SUBMITTAL COVERSHEET Nanuet UFSD -Phase 3 Projects

SHOP DWGS MIDDLE SCHOOL PIPING / COORDINATED WITH GPS SCANNING

<input type="checkbox"/> Reviewed	<input type="checkbox"/> Furnish as Corrected
<input type="checkbox"/> Rejected	<input checked="" type="checkbox"/> Revise and Resubmit
<input type="checkbox"/> Submit Specified Item

SAGE LOG NO. M-45

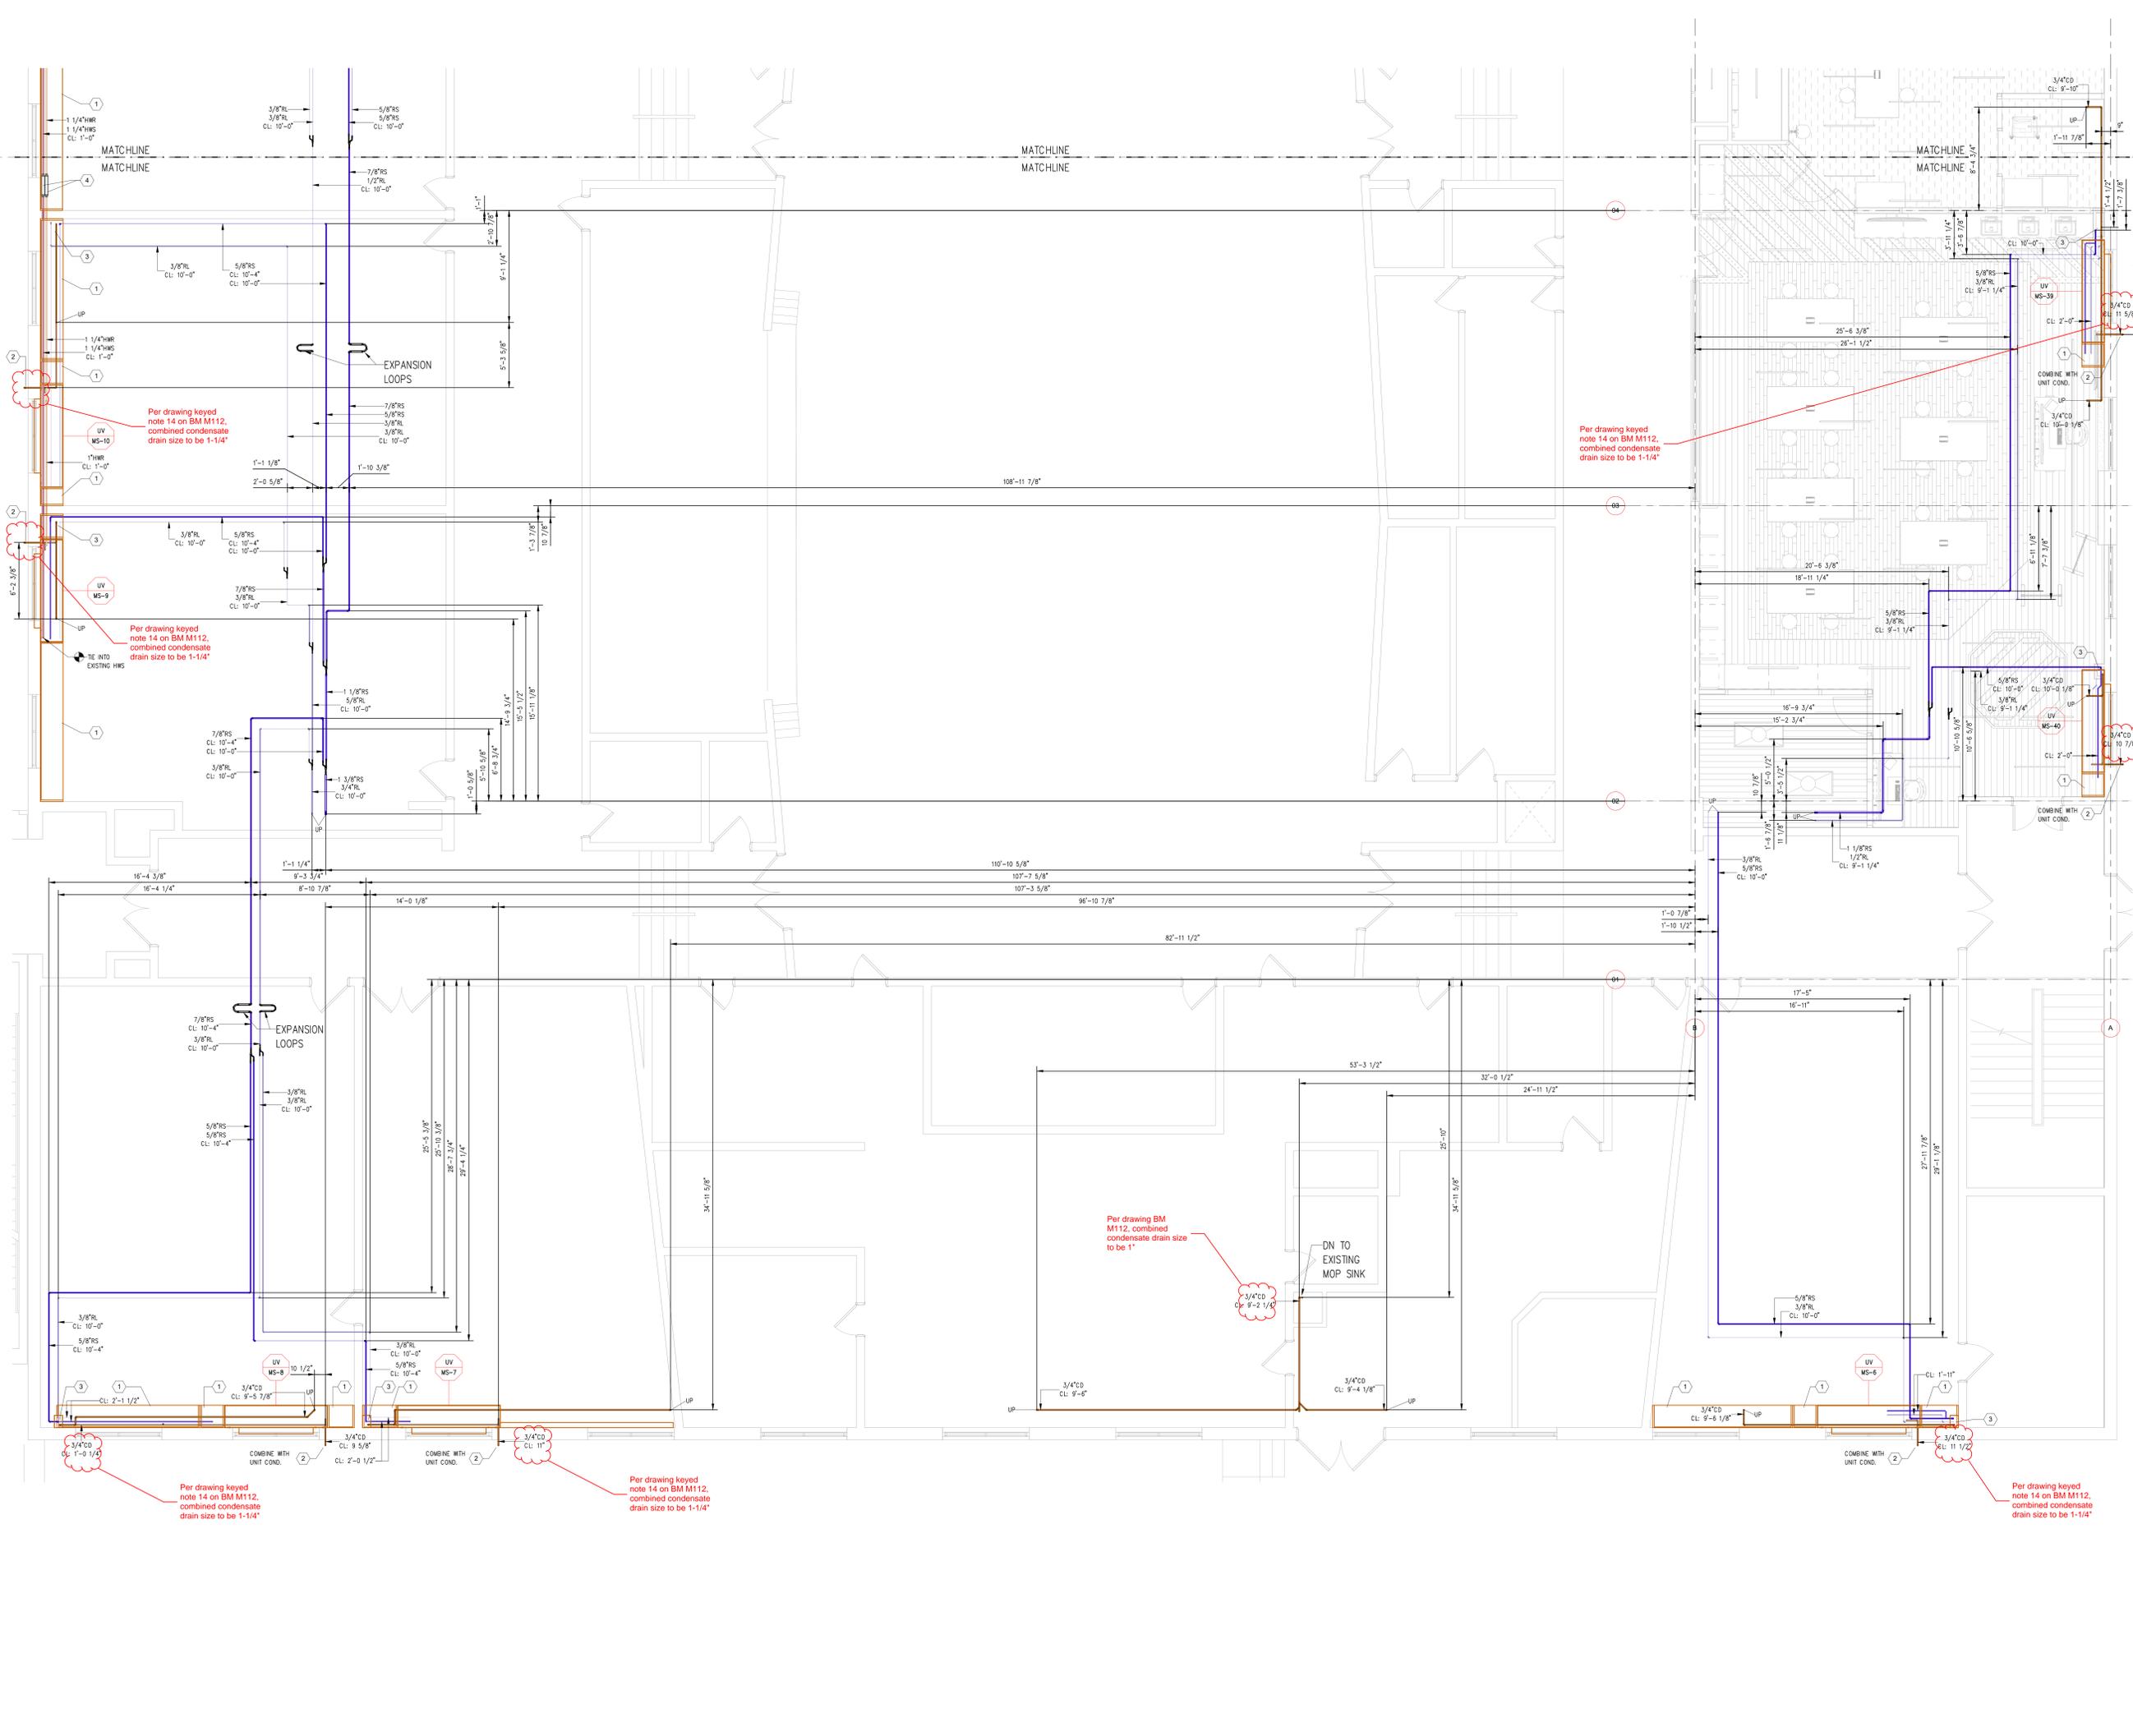
Per drawing keyed note 14 on BM M112, combined condensate drain size to be 1-1/4"

Per drawing keyed note 14 on BM M112, combined condensate drain size to be 1-1/4"

Per drawing keyed note 14 on BM M112, combined condensate drain size to be 1-1/4"

Per drawing keyed note 14 on BM M112, combined condensate drain size to be 1-1/4"

Per drawing BM M112, combined condensate drain size to be 1"

Per drawing keyed note 14 on BM M112, combined condensate drain size to be 1-1/4"

Per drawing keyed note 14 on BM M112, combined condensate drain size to be 1-1/4"

Per drawing keyed note 14 on BM M112, combined condensate drain size to be 1-1/4"

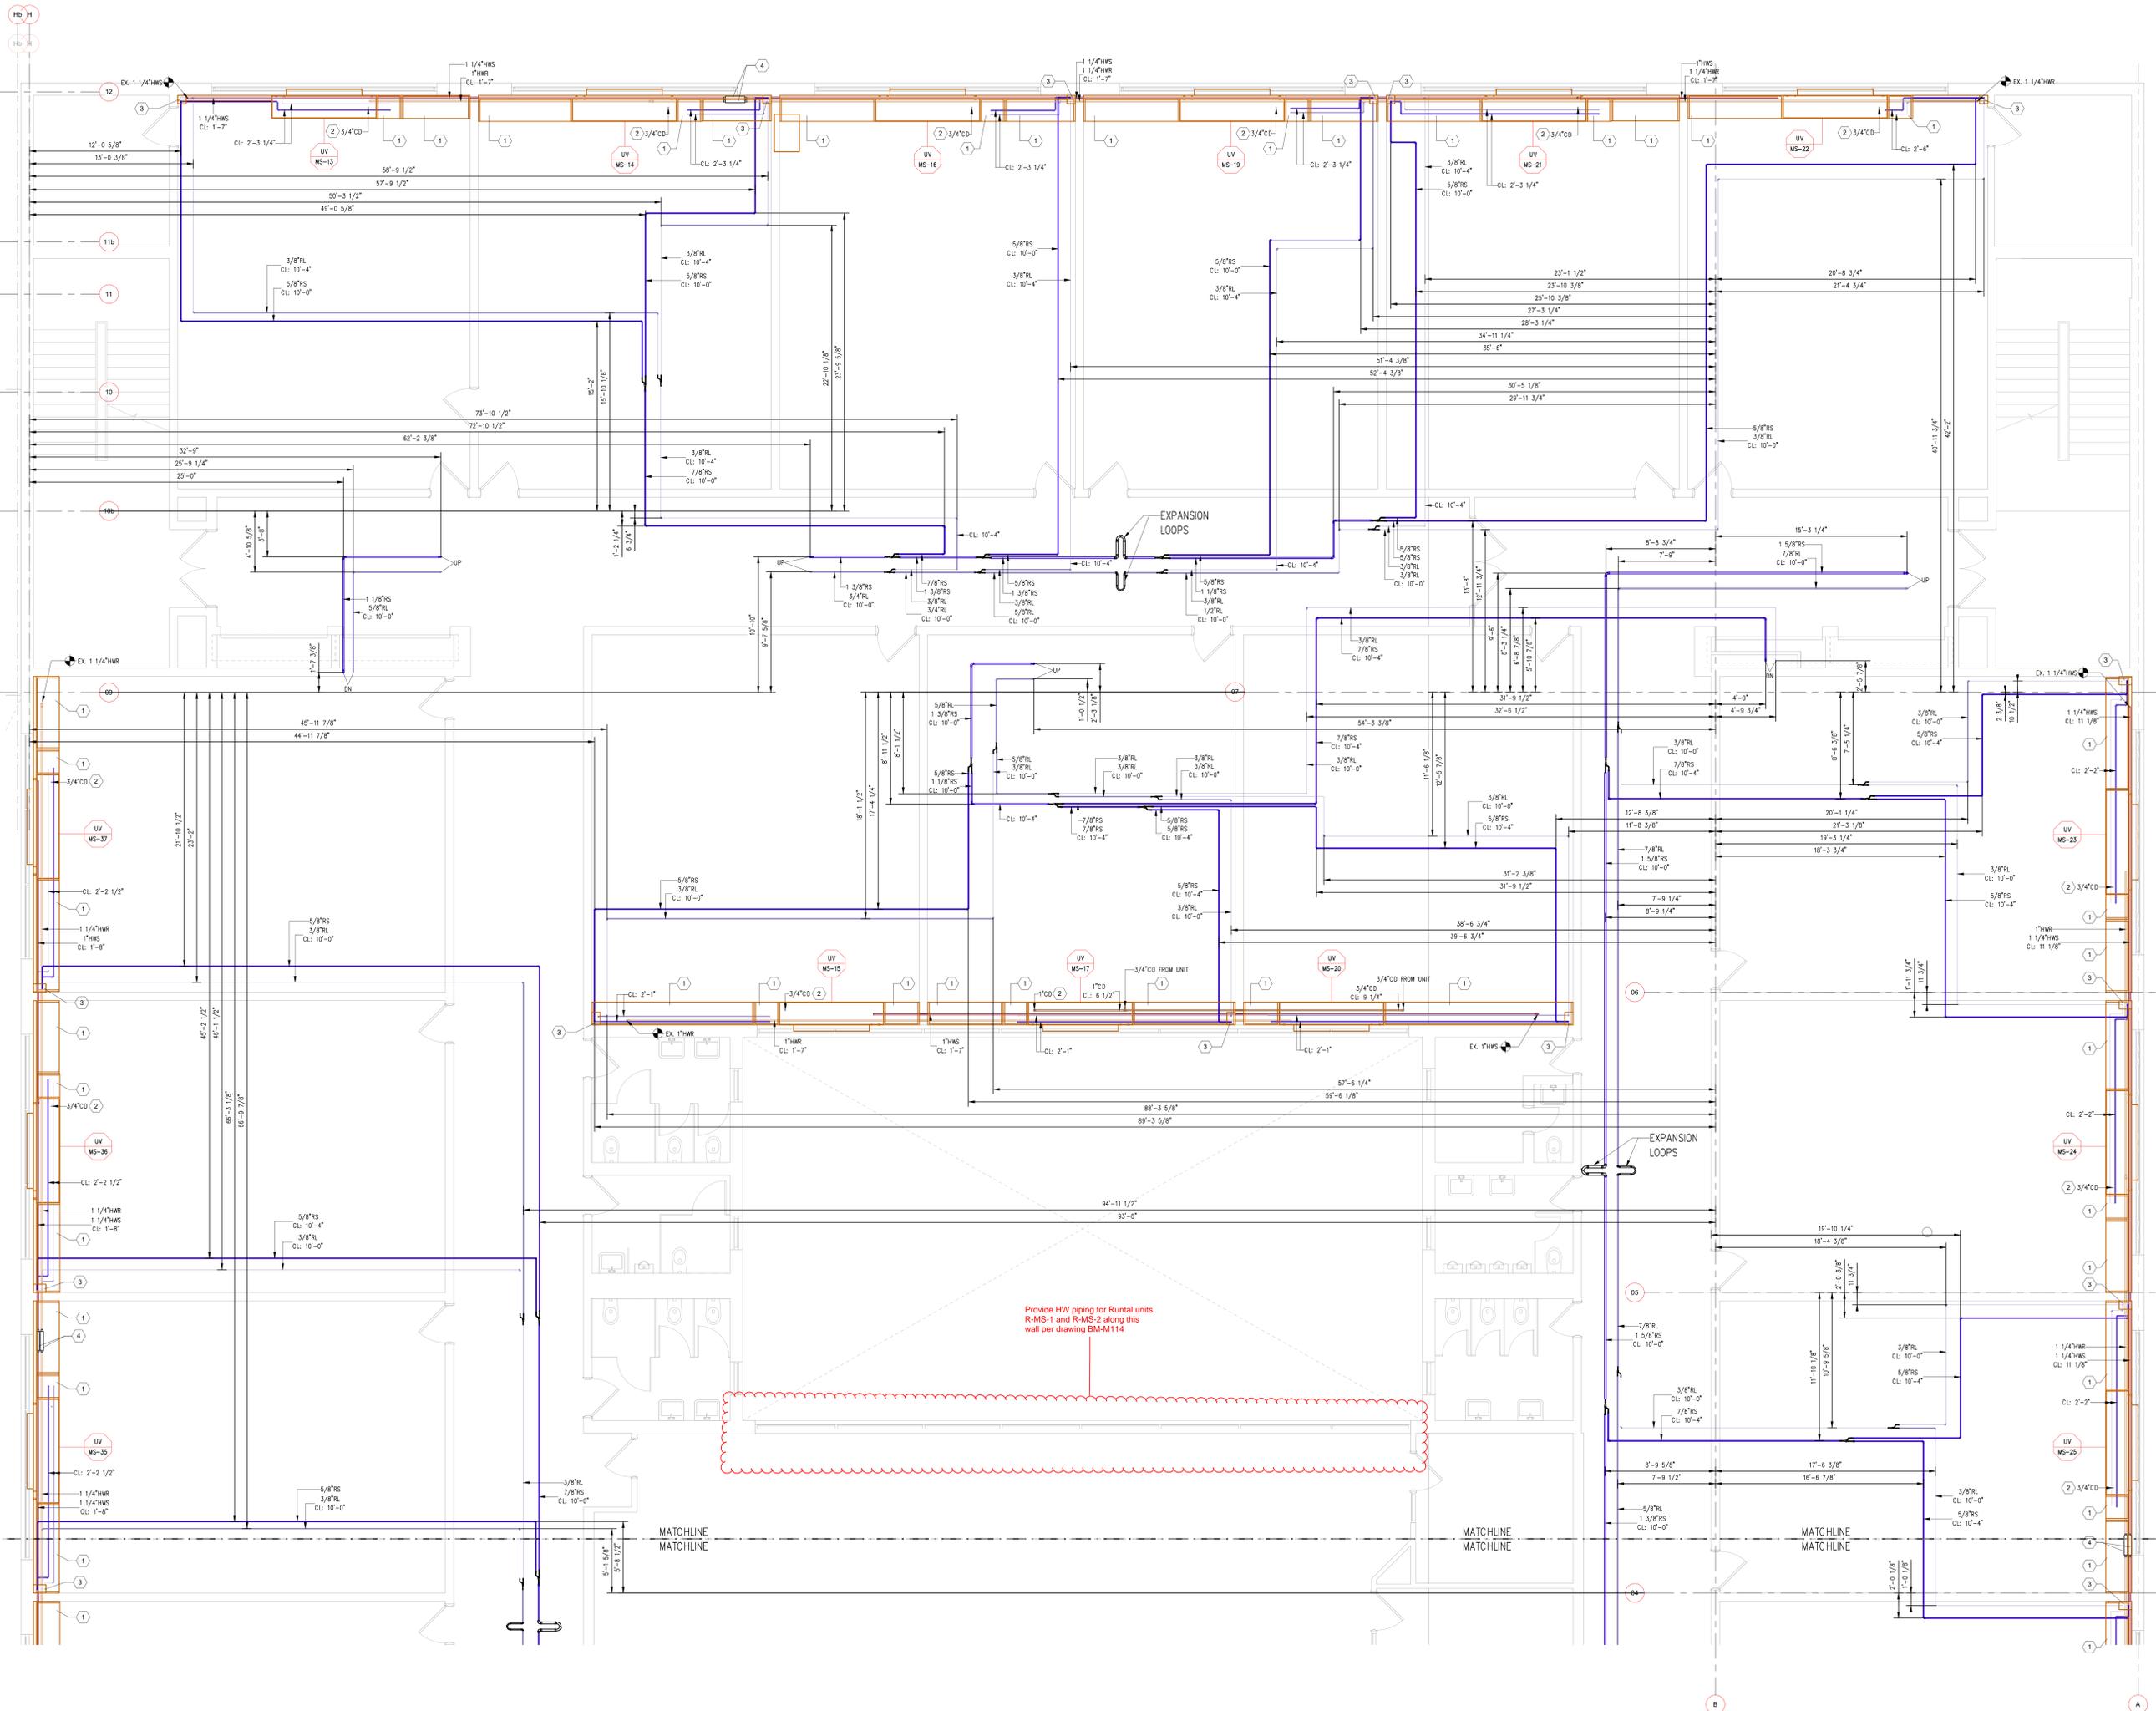
Provide HW piping for Runtal units R-MS-1 and R-MS-2 along this wall per drawing BM-M114

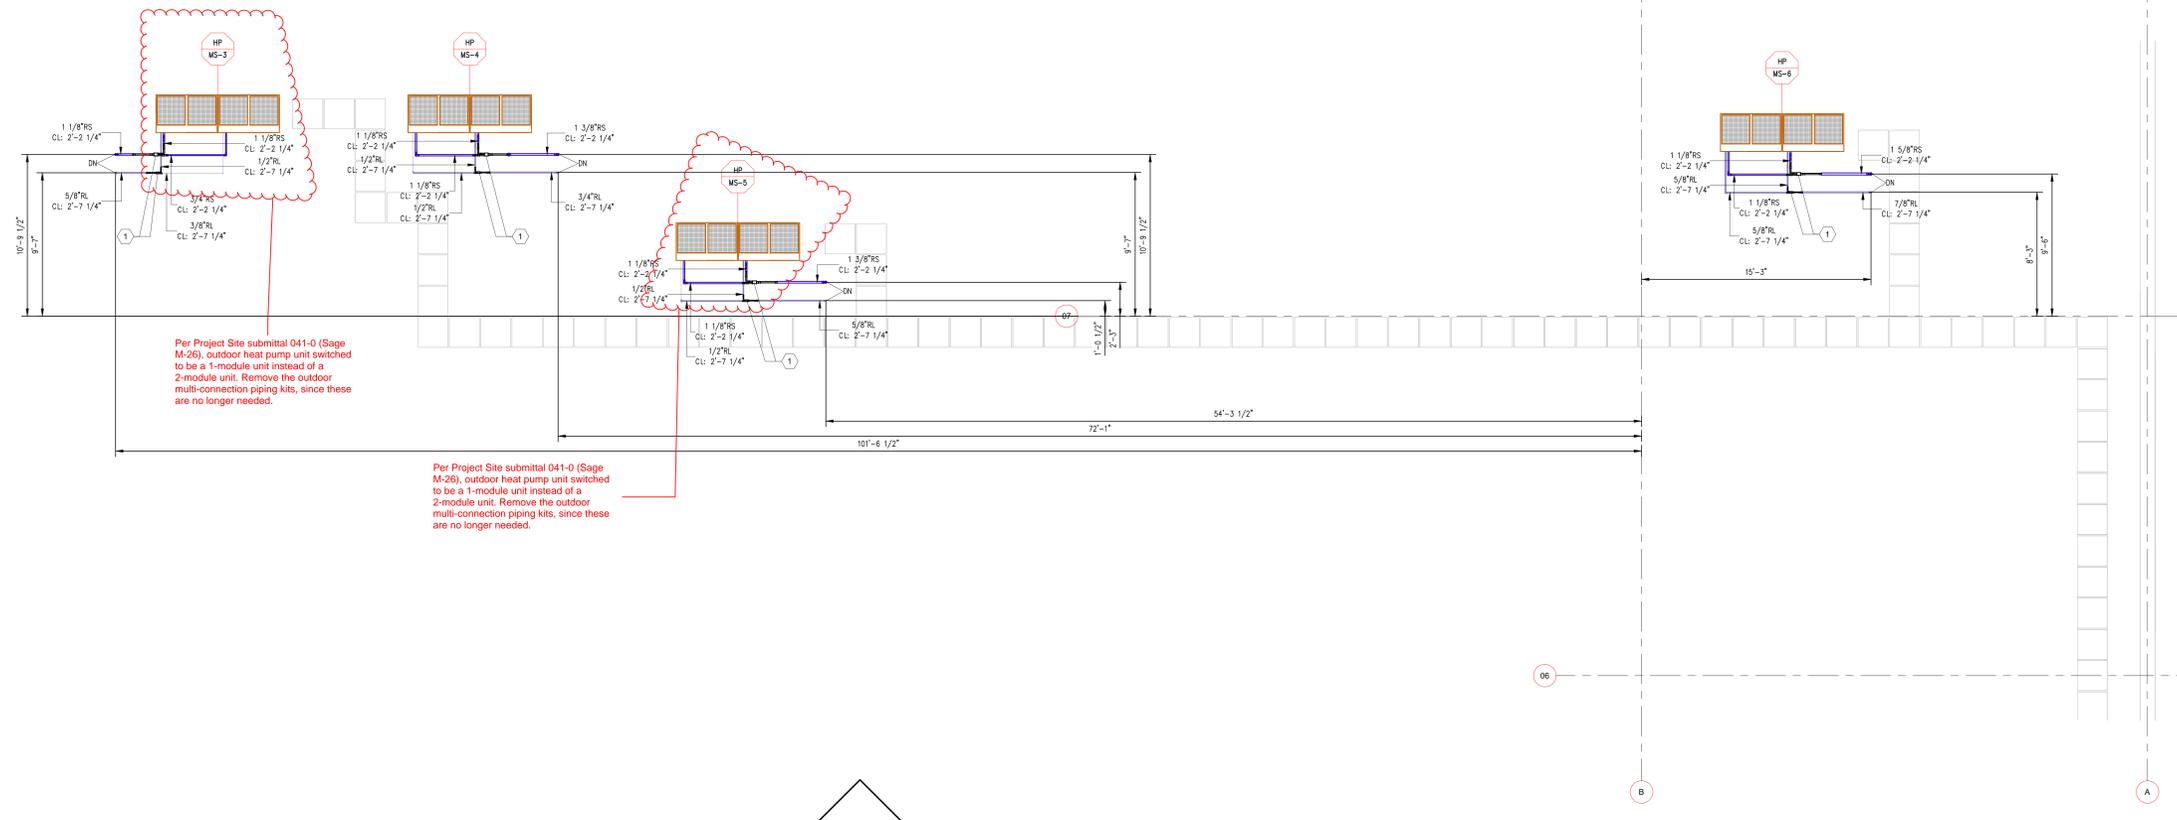
Per Project Site submittal 041-0 (Sage M-26), outdoor heat pump unit switched to be a 1-module unit instead of a 2-module unit. Remove the outdoor multi-connection piping kits, since these are no longer needed.

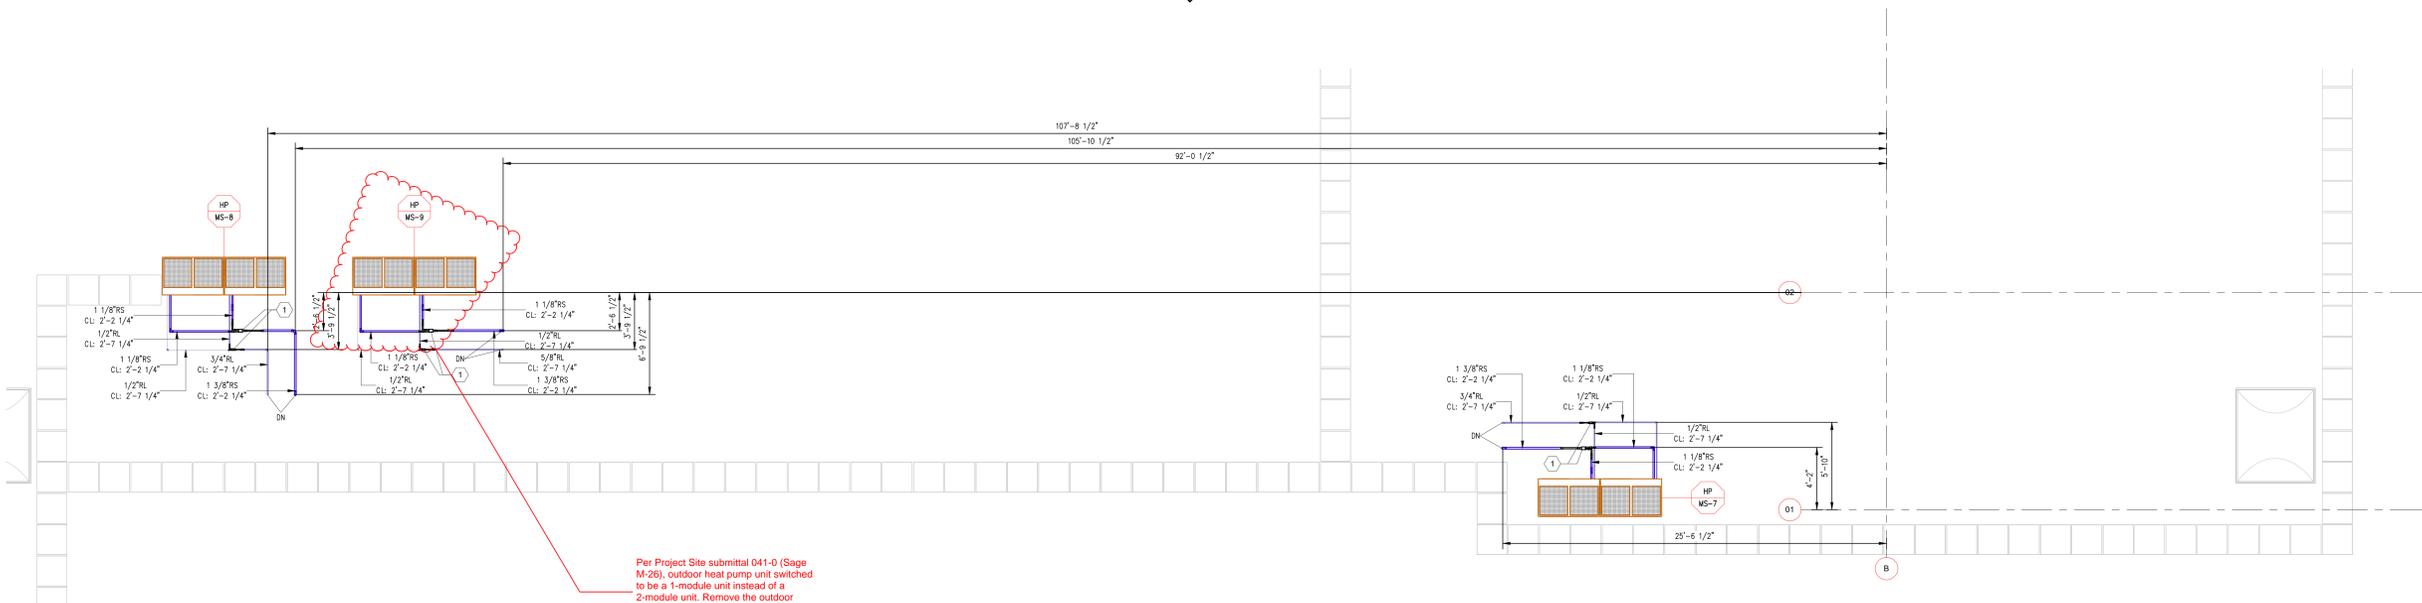
Per Project Site submittal 041-0 (Sage M-26), outdoor heat pump unit switched to be a 1-module unit instead of a 2-module unit. Remove the outdoor multi-connection piping kits, since these are no longer needed.

Per Project Site submittal 041-0 (Sage M-26), outdoor heat pump unit switched to be a 1-module unit instead of a 2-module unit. Remove the outdoor multi-connection piping kits, since these are no longer needed.
